UNITED STATES PATENT AND TRADEMARK OFFICE

APPLICATION NO.	FILING DATE	FIRST NAMED INVENTOR	ATTORNEY DOCKET NO.	CONFIRMATION NO.
10/016,174	10/30/2001	Edmund L. Wolak	P1292D1	1851
22849	7590	07/18/2002		
SCOTT W HEWETT 400 WEST THIRD STREET #223 SANTA ROSA, CA 95401			EXAMINER	LEUNG, QUYEN PHAN
			ART UNIT	PAPER NUMBER
			2828	
			DATE MAILED: 07/18/2002

Office Action Summary	Application No.	Applicant(s)
	10/016,174	WOLAK ET AL.
	Examiner	Art Unit
	Quyen P. Leung	2828

DETAILED ACTION

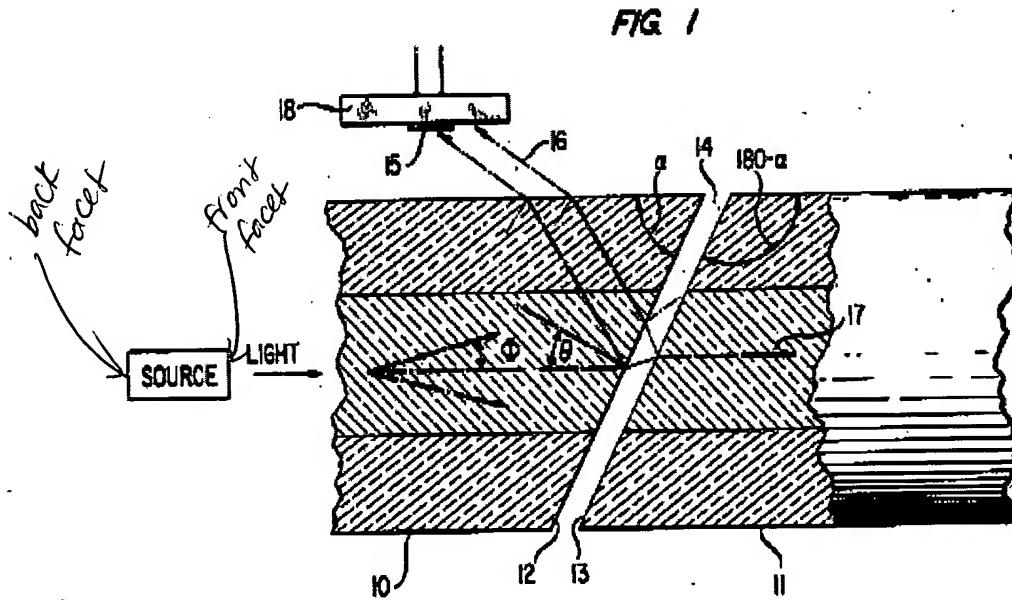
2. Claims 33-39 are rejected under 35 U.S.C. 102(b) as being anticipated by Di Domenico, Jr et al (4,165,496). Di Domenico, Jr et al discloses the claimed invention. For example, Figure 1 illustrates a laser module comprising a laser diode (35) having a

front facet, an optical fiber (11) having a fiber end (13) disposed proximate to the front facet to couple light emitted from the front facet to the optical fiber (11), the front facet and the fiber end (13) forming a coupling region there between and a monitor photo

diode (15) disposed to couple light from at least one of the fiber end (13) and the front facet.

Regarding the reflectance-increasing coating on the fiber end (13), note col. 3 lines 28-32.

FIG. 6

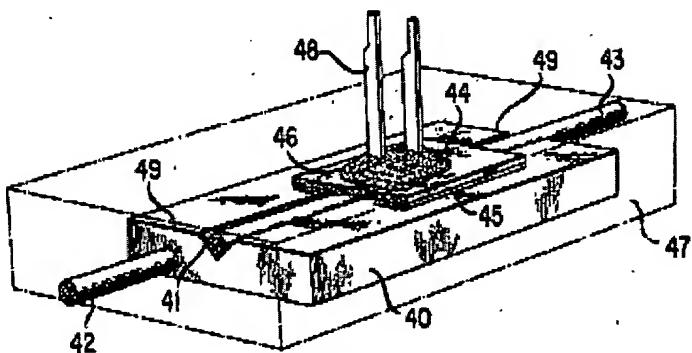
Regarding the substrate to which the laser diode and the optical fiber are mechanically coupled, note figure 6, element 40 and col. 5 lines 30-58. Note further the

submount (47) for mechanically coupling the substrate (40) to the laser diode and optical fiber.

FIG_2

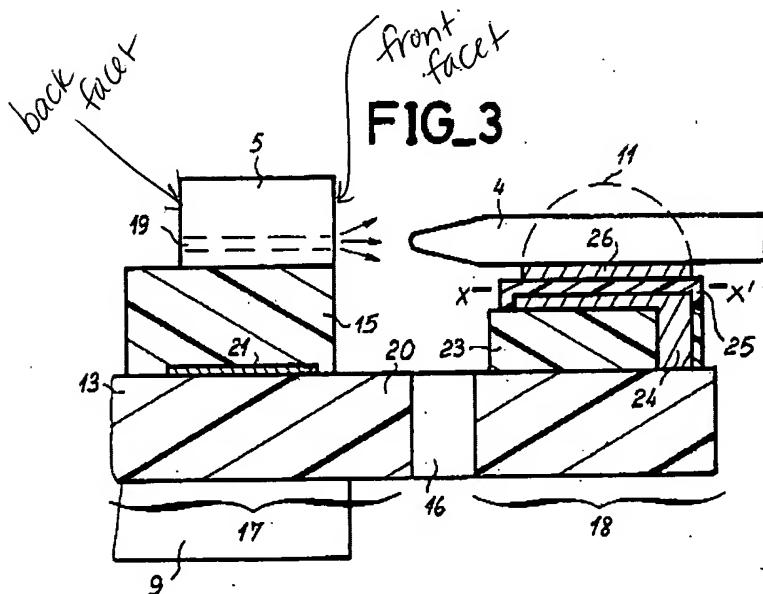
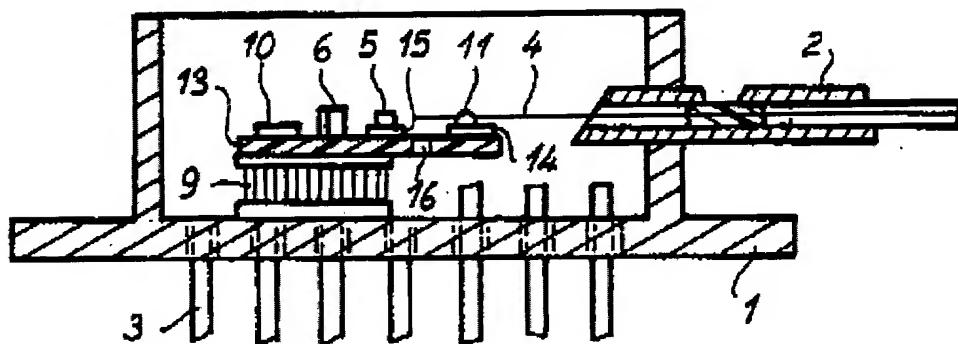
4. Claims 42-44 are rejected under 35 U.S.C. 103(a) as being unpatentable over Tournereau et al (4,807,956) in view of Harker (5,940,557). Tournereau et al discloses the claimed invention except for explicitly teaching a lens edge that is not perpendicular to the center axis of the optical fiber. Note figures 2 and 3 a laser diode source (5)

having a laser cavity between a front facet and back facet; an optical fiber (4) having lensed fiber input end disposed proximate to the front facet of the laser diode source (5)

to receive a first light output from the front facet; and a laser monitor disposed proximate to the back facet of the laser diode source (5) to receive a second light output from the back facet, the second light output including amplified back-reflected light.

Fig. 1

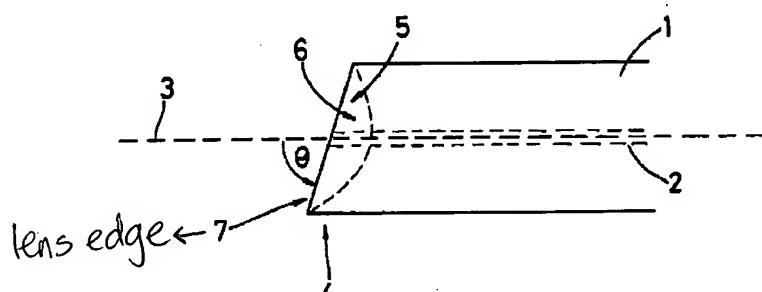
As shown in figures 1-5 and discussed in col. 4 lines 23-29, Harker teaches a

lens edge that is not perpendicular to the center axis of the optical fiber, for the advantageous benefit of minimizing the disturbing of operation of the laser diode. It would have been obvious to one of ordinary skill in the art to modify Tournereau et al by employing a lens edge that is not perpendicular to the center axis of the optical fiber, as taught by Harker et al, for the advantageous benefit of minimizing the disturbing of operation of the laser diode.
